The above hereby request permission to construct a: X driveway / Plot 35 sidewalk located at 35 Borden St, Lot 49 to be constructed in accordance with the city's latest construction standards and specifications and adhere to the Ordinances of the City of New Bedford.

## Driveway Review

**Driveway Review Form**

Sketch

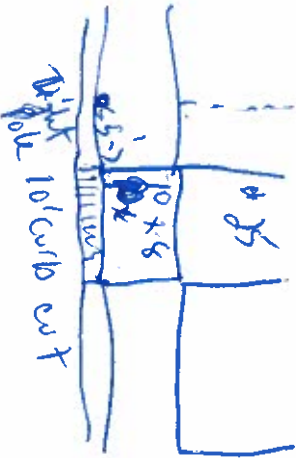
Remove 10' curb  
Remove 10 x 8 sidewalk  
Install 10 x 8 concrete apron
